Final Environmental Initial Study and Mitigated Negative Declaration

Palomar College, San Marcos Campus West Comet Circle Parking Lot IS/MND

COMMENTS RECEIVED ON THE DRAFT MND AND RESPONSES

REVISED LANDSCAPE PLAN

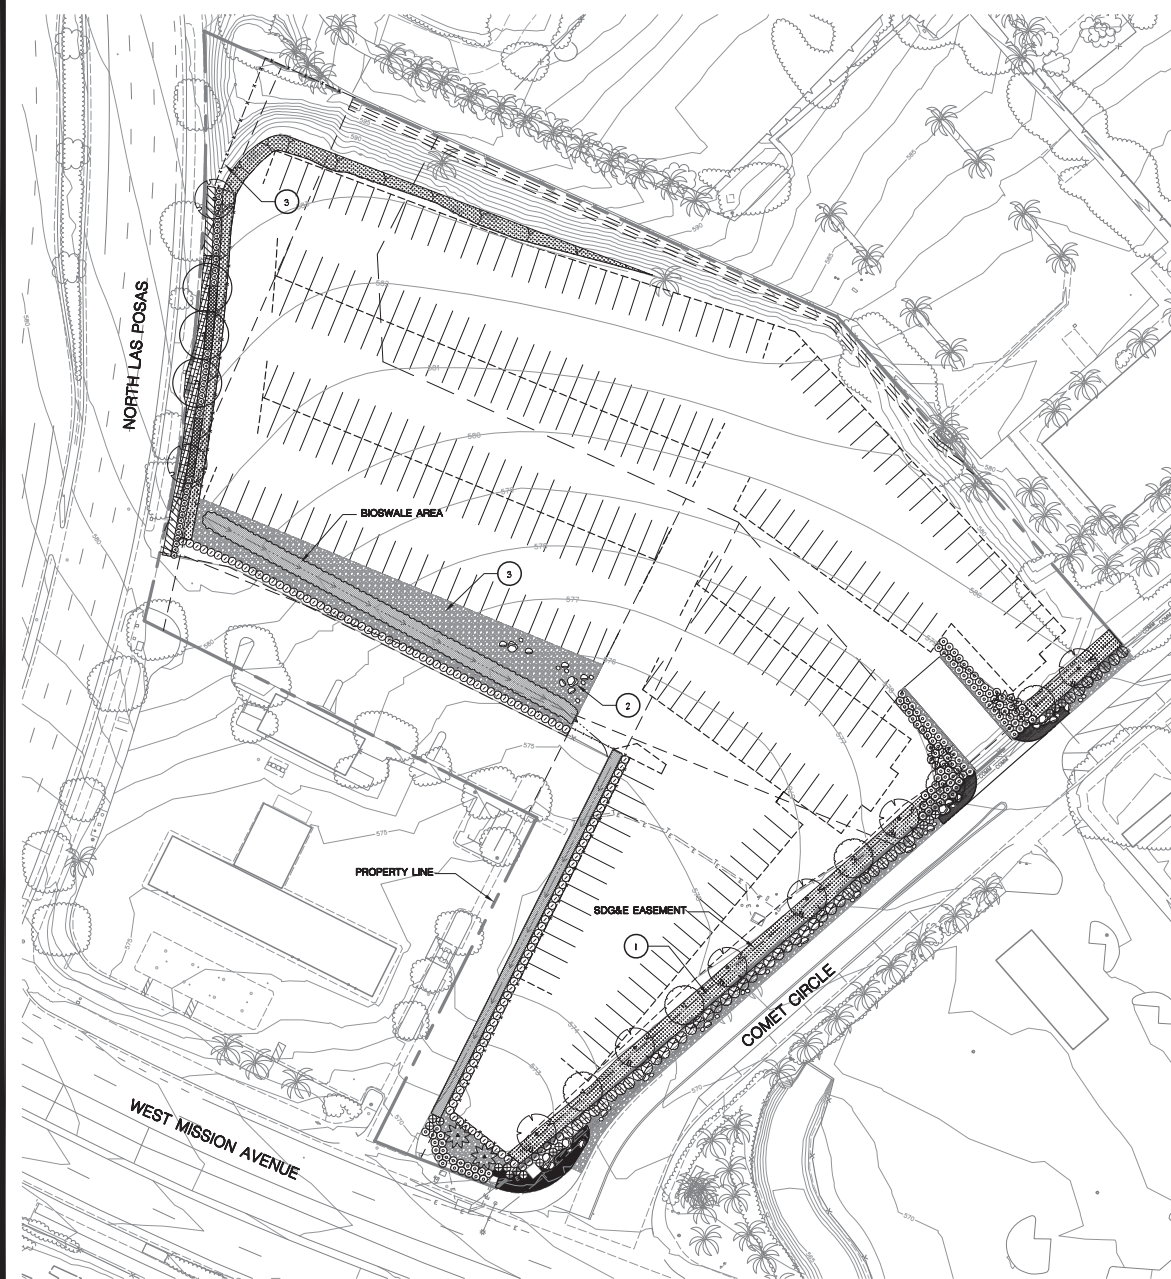
- B-3 ○ The project will include landscape installation around the perimeter of the lot, however trees are not proposed along the interior lot line. The City requests that the landscape be provided along the entire lot perimeter, and that a below ground irrigation is provided to ensure planting survival.

2. Comment noted. PCCD will be applying for a project specific Construction General Permit (CGP).
3. Comment noted. The landscape plan has been revised (see page 11) to propose native landscaping on the south, west and east sides, with the north side containing an existing vegetated slope and a dense thicket of vegetation at the northeast corner of the site. The west (Las Posas Road) side has a low berm with trees and landscaping to complement the existing theme along Las Posas Road. The south (Mission Road) side has transplanted existing Brahea palm trees, a screening hedge, low groundcover planting, and some cobble as an inert material groundcover. The interior perimeter along the north and east sides of the gas station has a screening hedge in front of the perimeter fence. There are also vegetated bioswales on the interior side of the fence. The east (West Comet Circle) side of the parking lot has screening landscaping and trees to accentuate the vehicular corridor of West Comet Circle. Cobble and boulders are also used along the west side of West Comet Circle to discourage pedestrian traffic on that side of the road. The entire site is screened from exterior views. All of the plantings are native species and will be served by an automatic underground irrigation system that meets all state and local water conservation ordinances. Fertilizers will not be used on the native plants specified in the plan, thus creating no nutrient runoff from the site.

Figure 6
Project Design

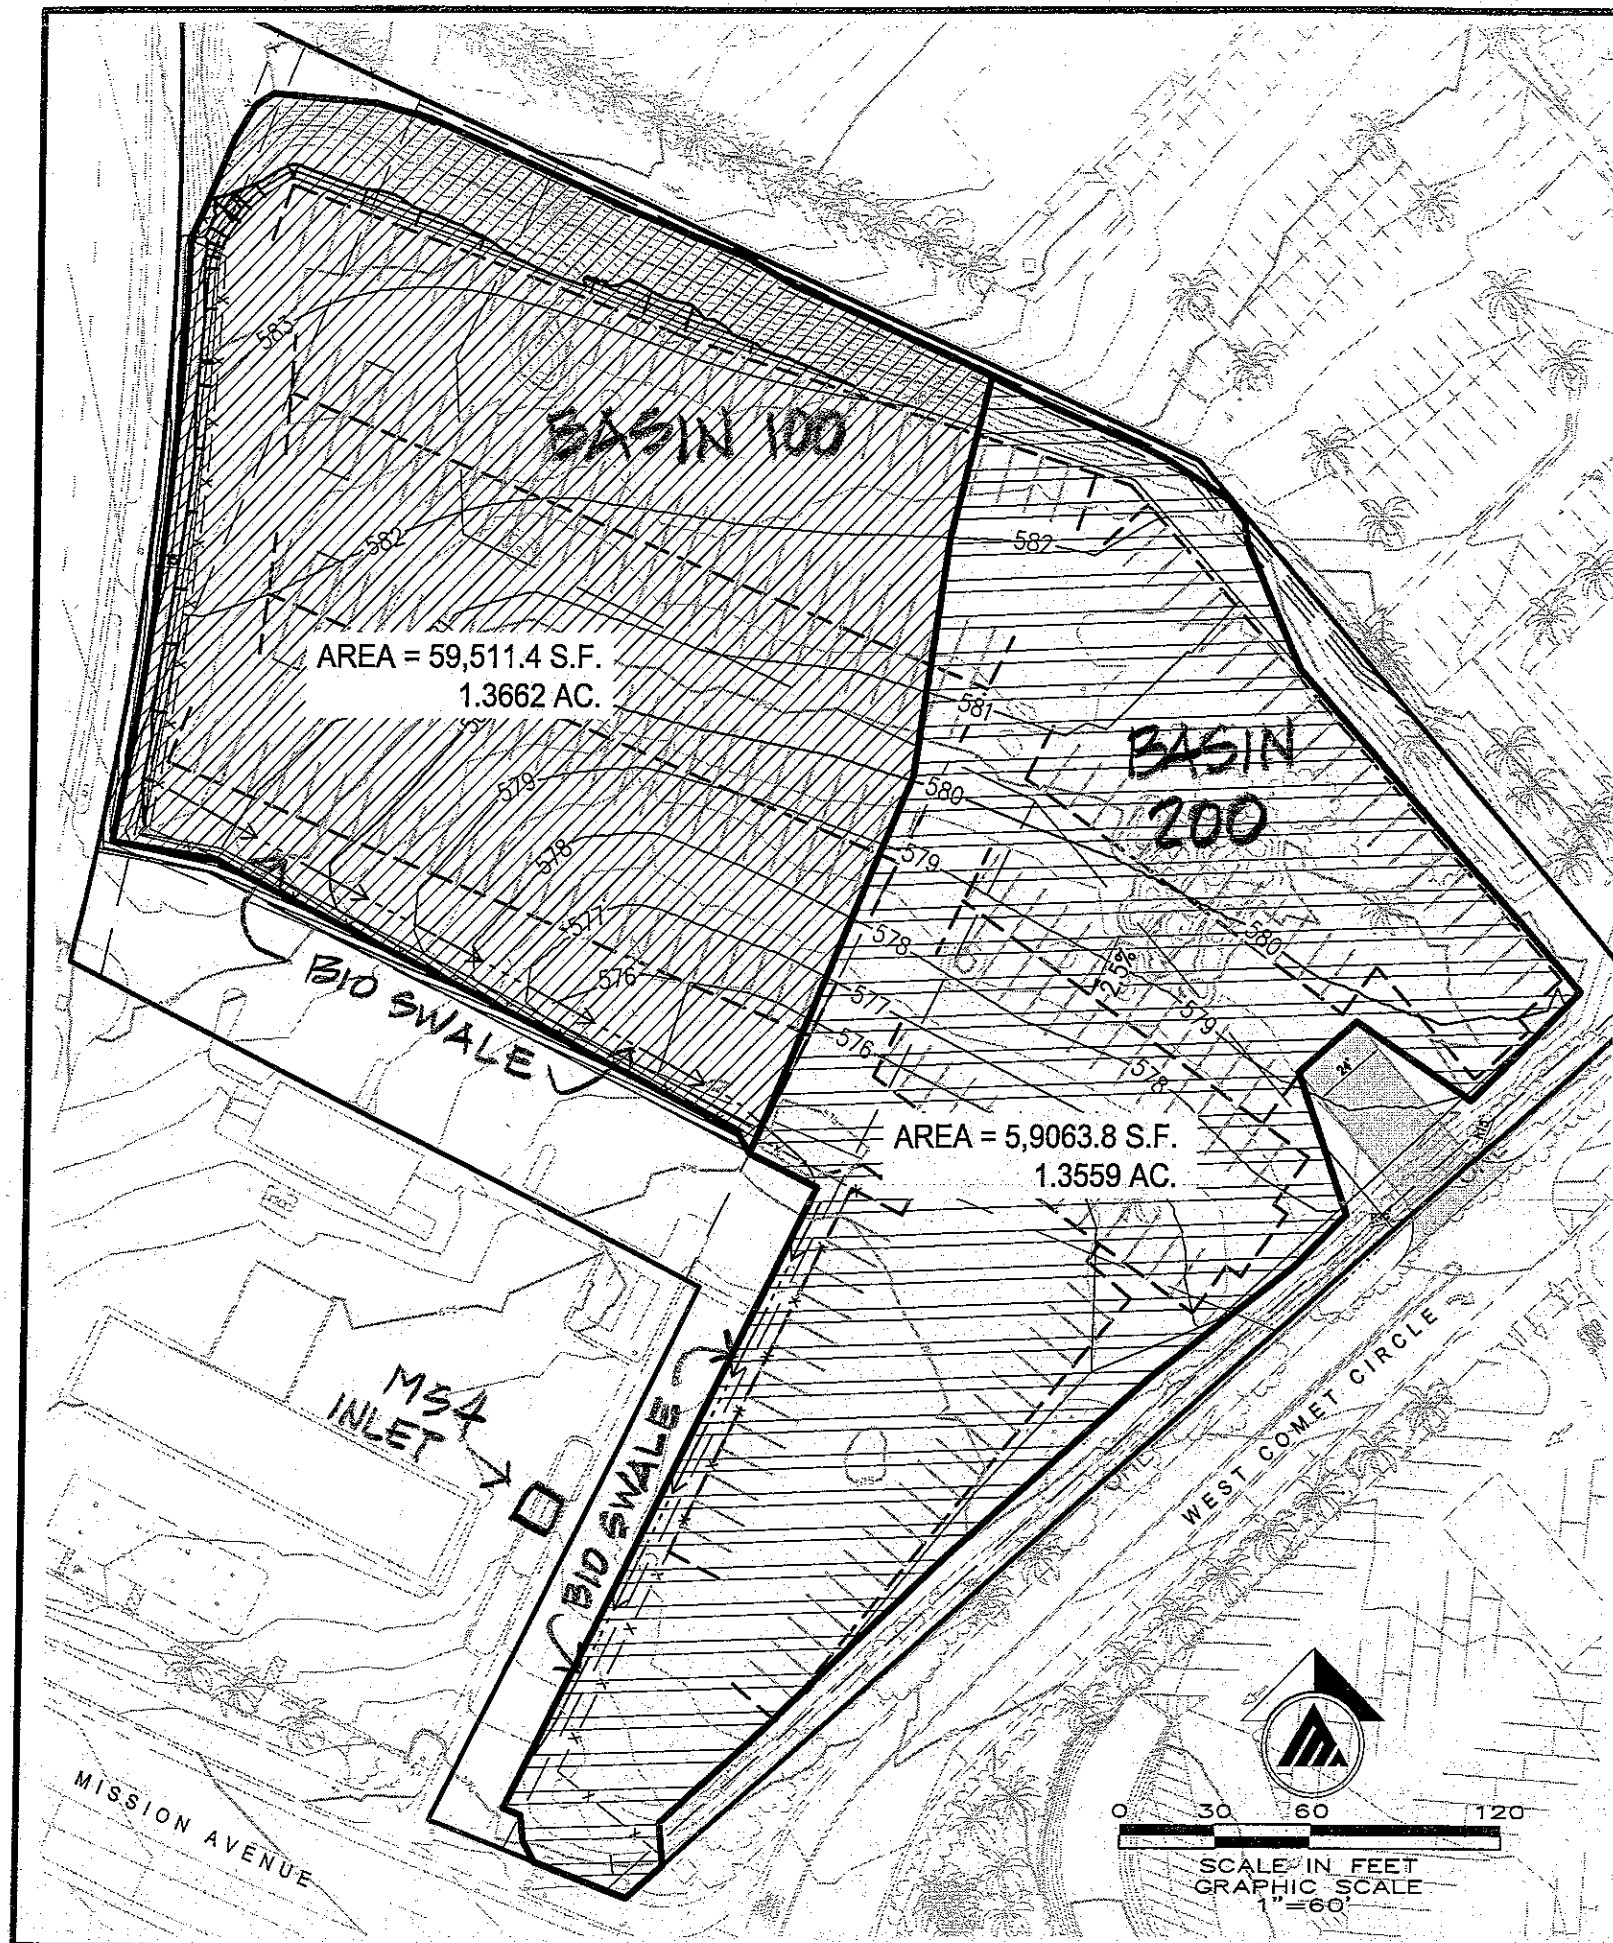
- A calculation sheet needs to be included to show that the vegetated swale is meeting CASQA design requirements needs to be included to demonstrate that the City is not accepting polluted stormwater into its MS4 system.

- A point should be added to the engineering plan showing the connection to the City MS4. Please also show that the water flowing to the swale area is fully captured by the vegetated swale and treated prior to surface flow out into the MS4 system.

6. Comment noted. Please see the WQTR as Attachment A.
7. Comment noted. See Figure 7 for details of the vegetated bioswales. The vegetated bioswale provided in the current Project Description is for backup treatment only. The 85th percentile storm will not see surface runoff leaving the site. Since the current project does not meet the criteria for a priority project and the gravel surface and new landscaping can be depicted as self treating there is no need for calculations.

8. Comment noted. Please see Figure 7 for the location of the inlet to the City MS4.
9. Comment noted. The requirement for The Best Management Practices (BMP's) is mentioned in question 8f and in the Mitigation and Monitoring Program of the IS/MND. The BMP's for the Storm Water Management Plan (SWMP) and construction practices are addressed. The BMP's are fully defined in the Program Environmental Impact Report (PEIR), which this IS/MND is tiered off of. As stated above the project is under the jurisdiction of the CGP. Therefore, the Storm Water Pollution Prevention Plan (SWPPP) that will be prepared for the project will
